DATE: April 11, 2018

<u>Certificate of Appropriateness Request:</u>	H-04-18
<u>Applicant:</u>	Aavis Clark/Westminster Presbyterian Church
<u>Location of subject property:</u>	127 Cabarrus Ave. W
<u>Staff Report prepared by:</u>	Scott Sherrill, Sr. Planner

Forest Hill
United Methodist Church

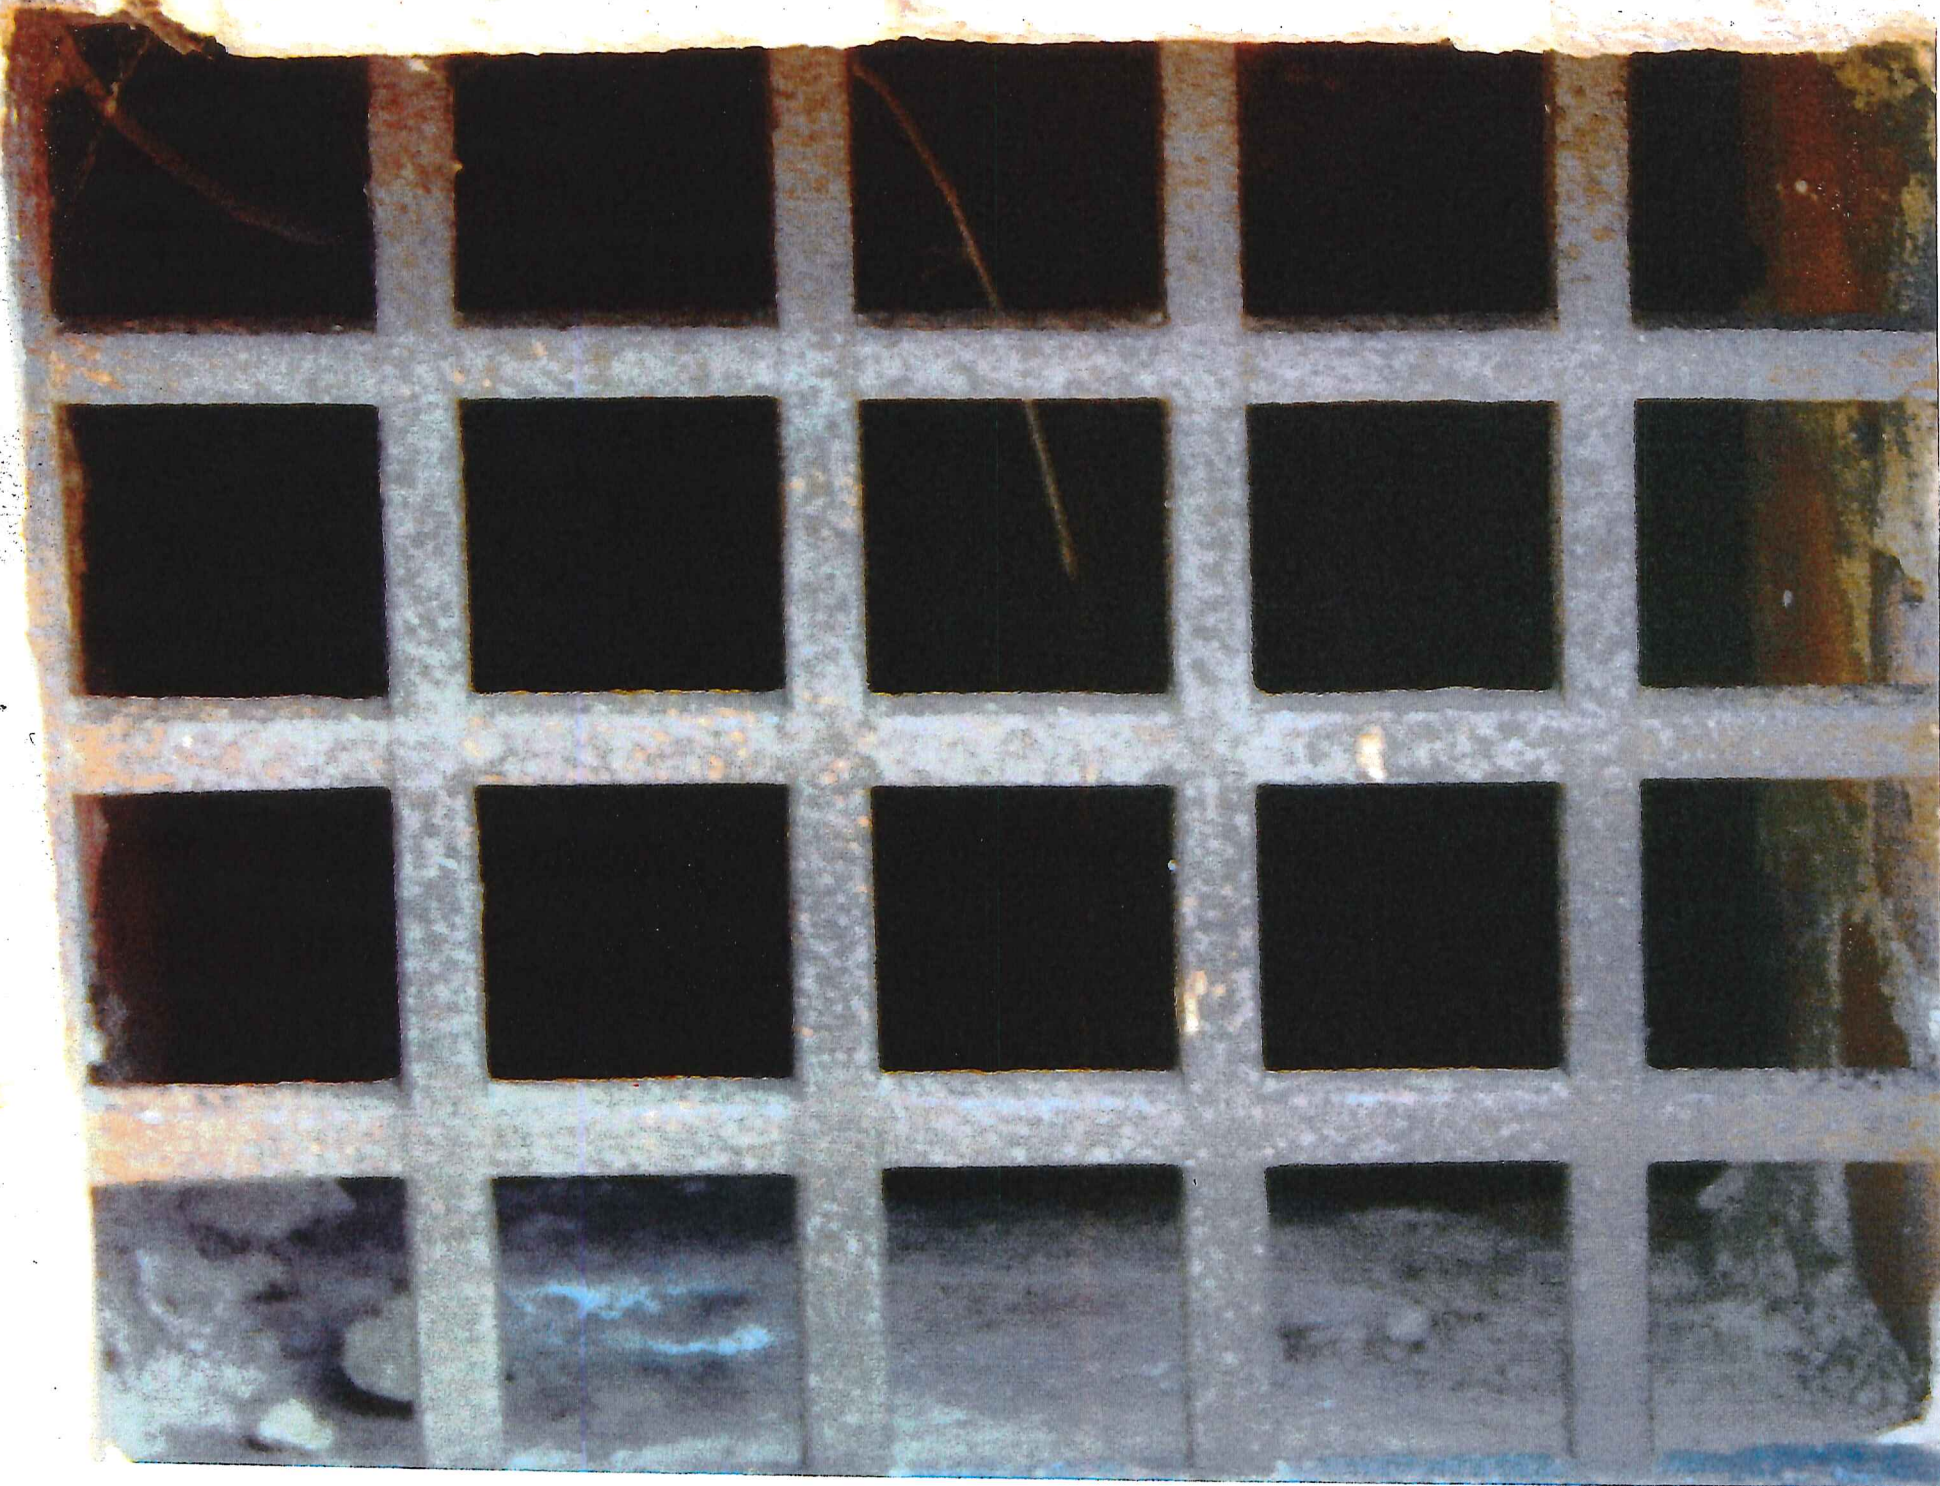
The applicant is seeking approval to replace the existing doors of the church with wooden doors in a style similar to that of the Forest Hill United Methodist Church Historic Sanctuary, but designed to fit within the existing door openings.

EXTERIOR DOORS

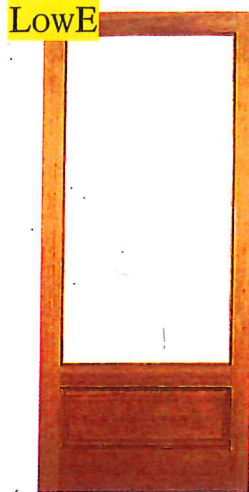
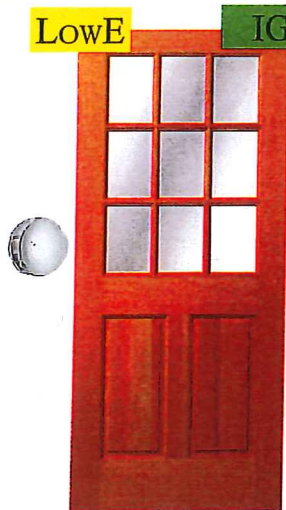
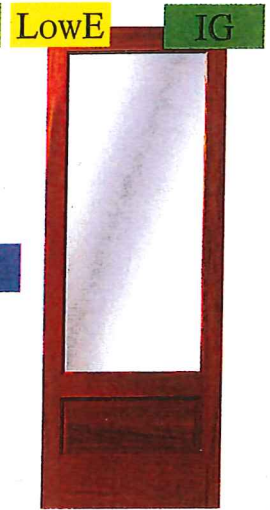
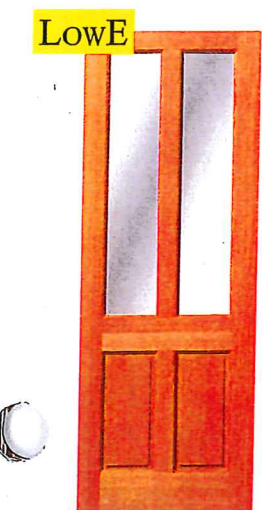
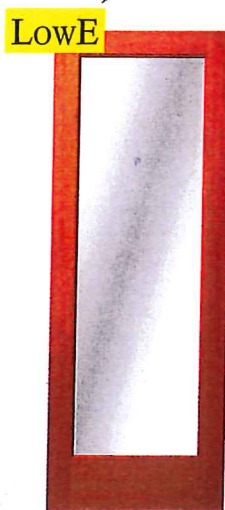
The applicant is proposing to enclose the rear porch, adding a door to the outside, which would match the proposed replacement for the front door. The applicant is proposing to replace five doors in total on the structure, with all matching. The enclosure would be accomplished by replacing the screen with glass, and would result in two windows on the rear façade of the porch and one on the side.

VictorBilt Traditions Series Windows

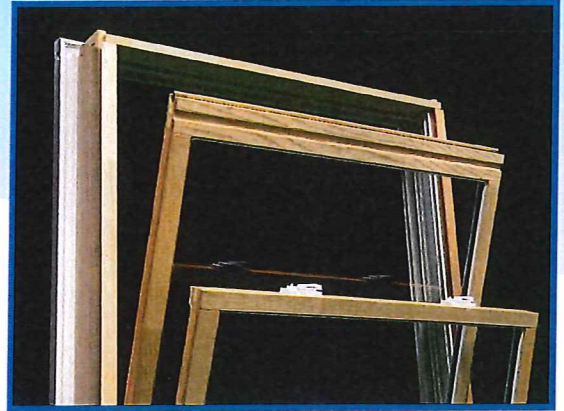
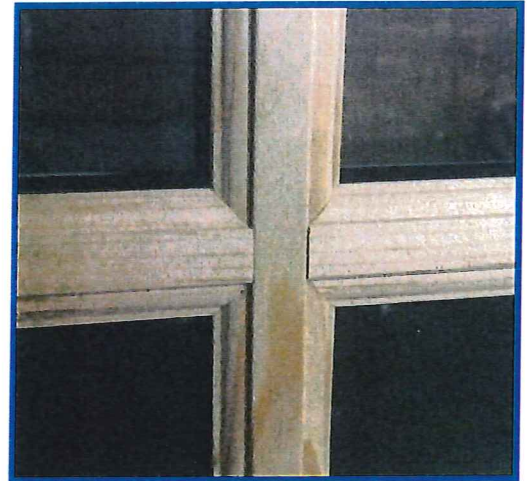
Applicant is seeking approval to replace the original windows at 17 Georgia St with VictorBilt wood windows that match the existing styles and have true divided light. The applicant is also proposing to remove the shutters from the front façade of the house.

TREE RISK ASSESSMENT FORM

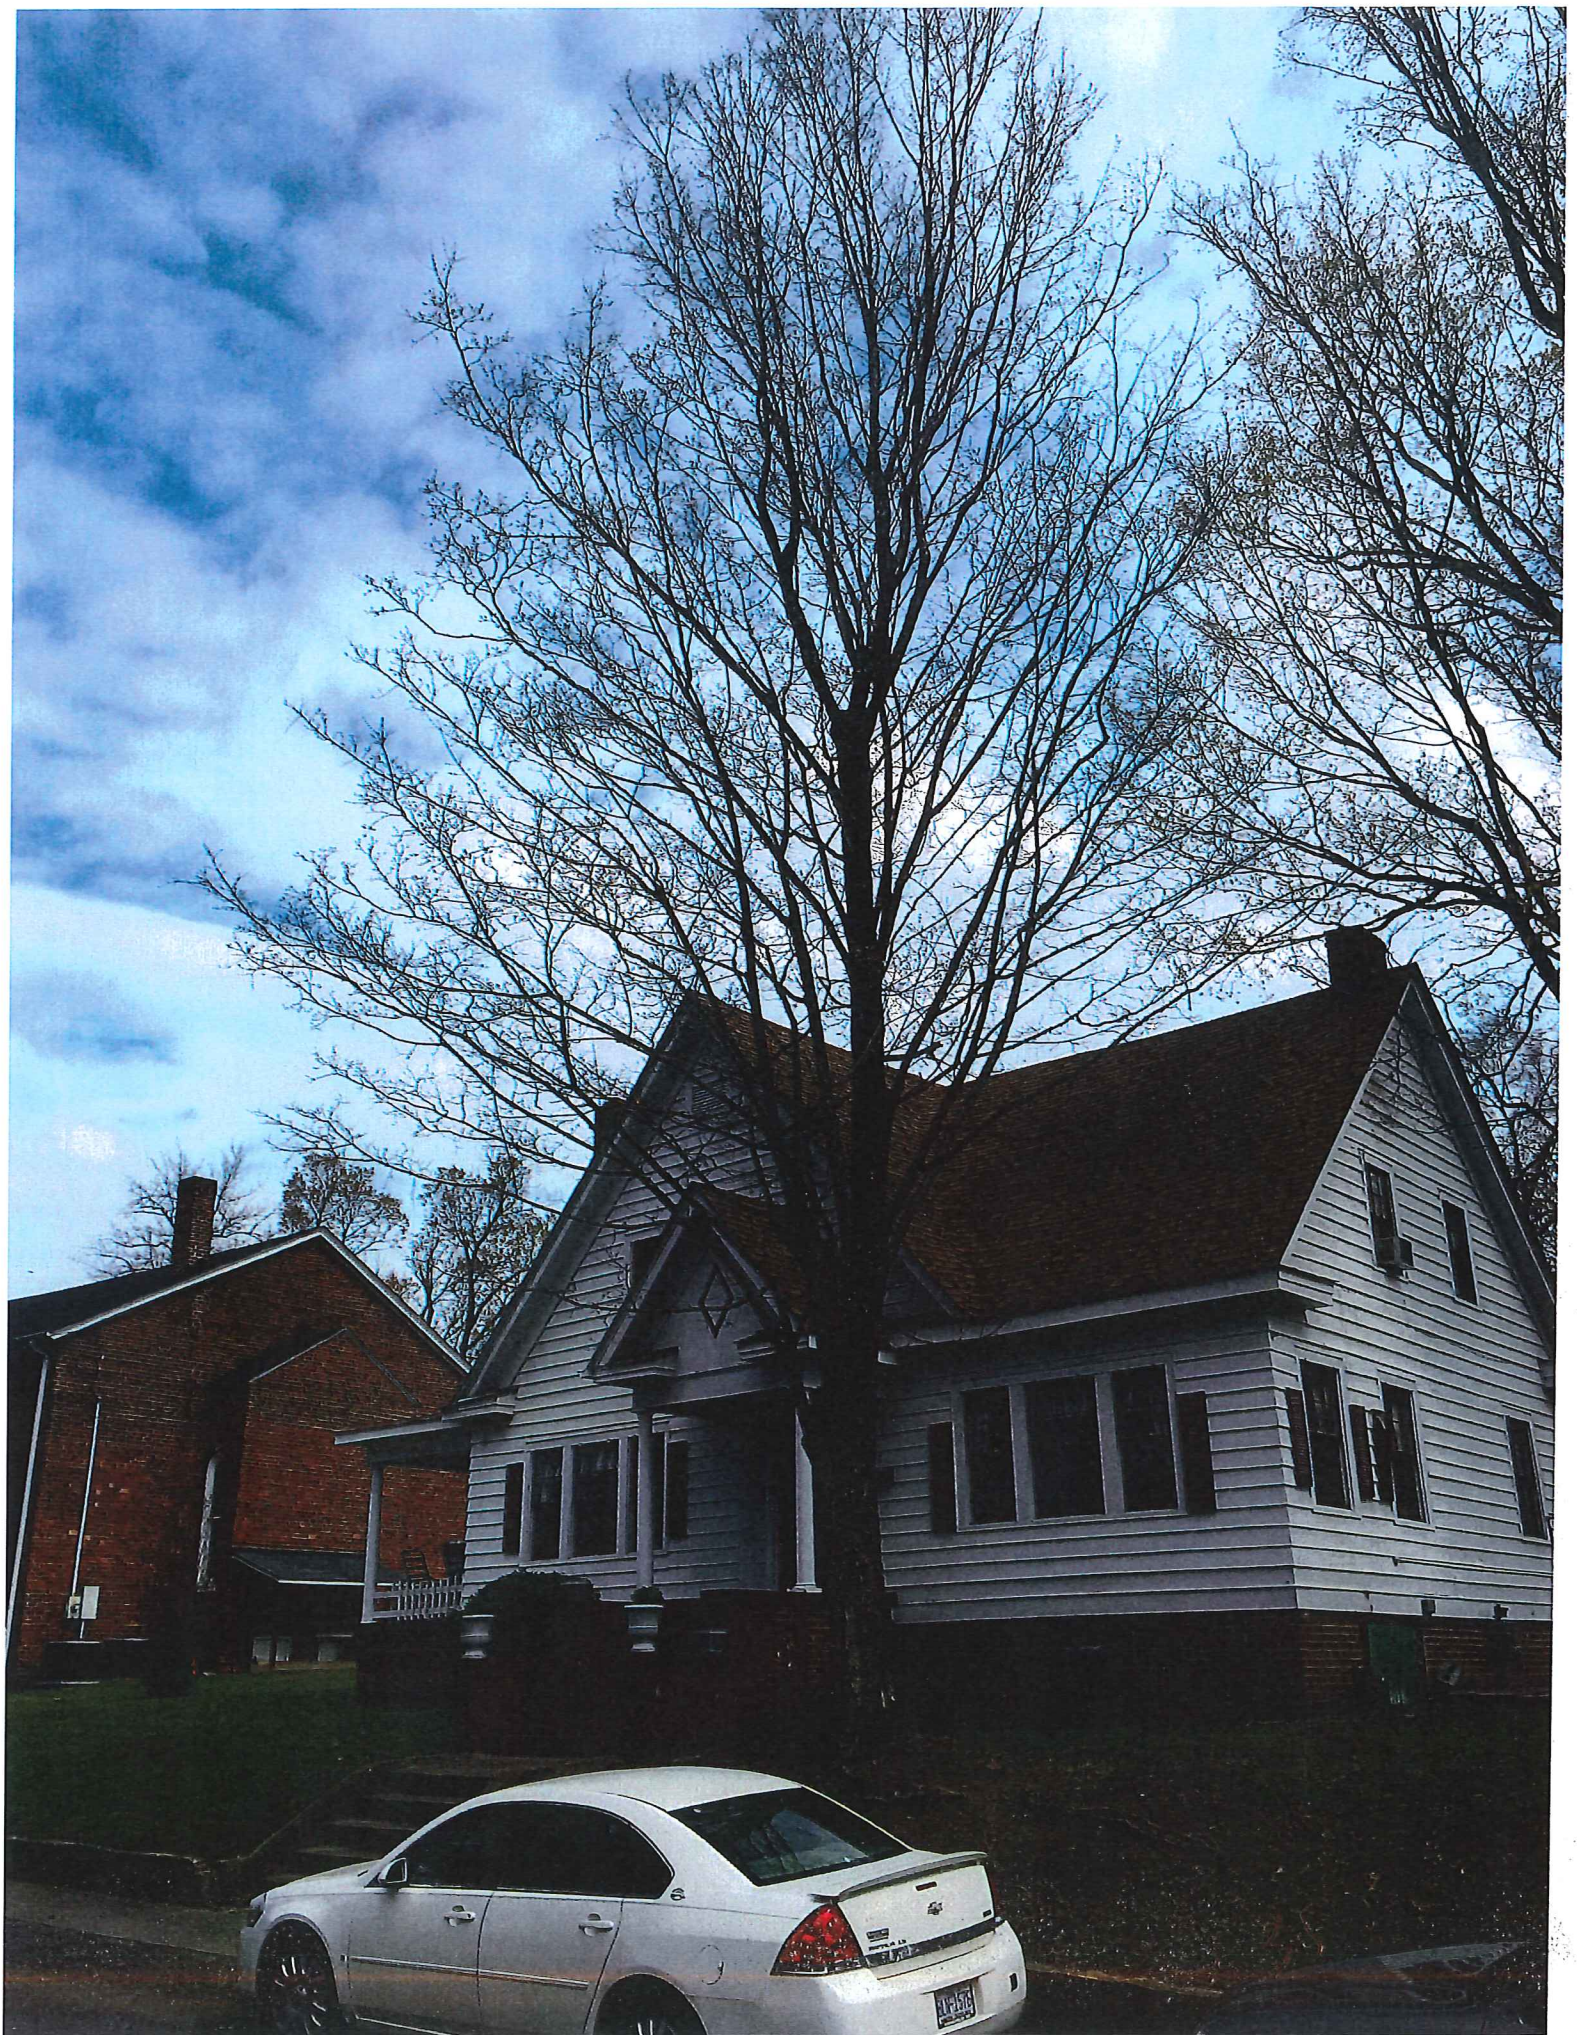
The applicant is proposing to remove two trees: Tree #1 is subject to Historic Preservation approval; Tree #3 will be approved at the staff level. Tree #1 has a hazard rating of 4.

This tree is in good structural condition. There are several exposed roots that have localized damage and decay. Proposed house renovations could impact the root system of this tree.
